WORK SESSION ISSUE LOWER CAVE CREEK FLOOD PLAIN CONCEPT STUDY

RE: Lower Cave Creek Flood Study Work Session

LOWER CAVE CREEK WASH FLOOD STUDY
MITIGATION: ARIZONA CANAL TO SALT RIVER

JANUARY 12, 1996

INFUSER

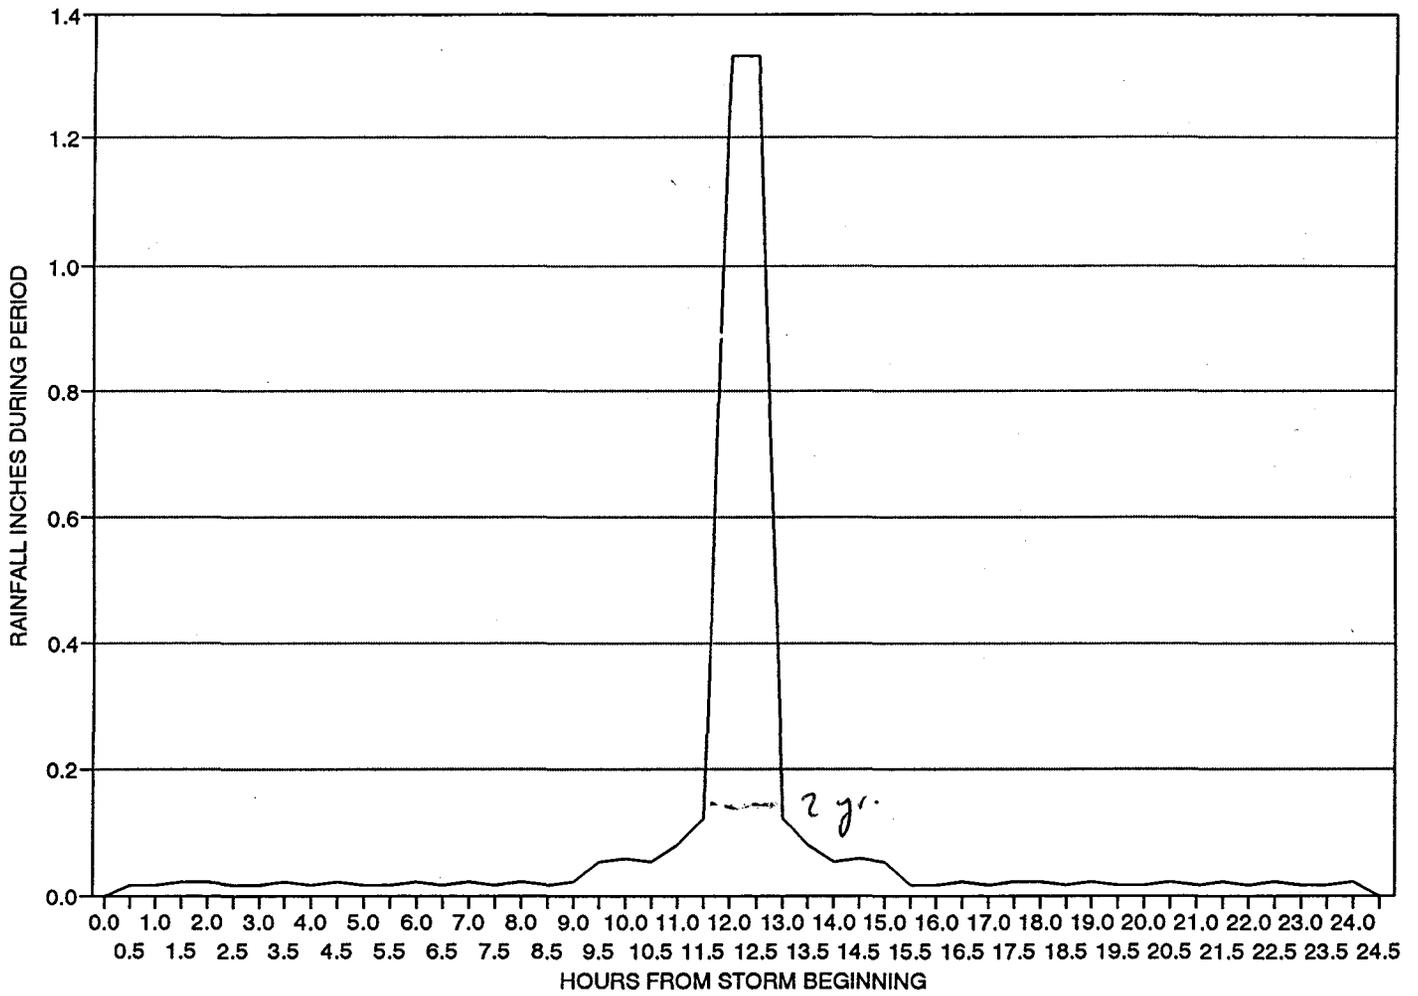
Probably better
to show runoff
hydrograph ~~vs.~~ instead.
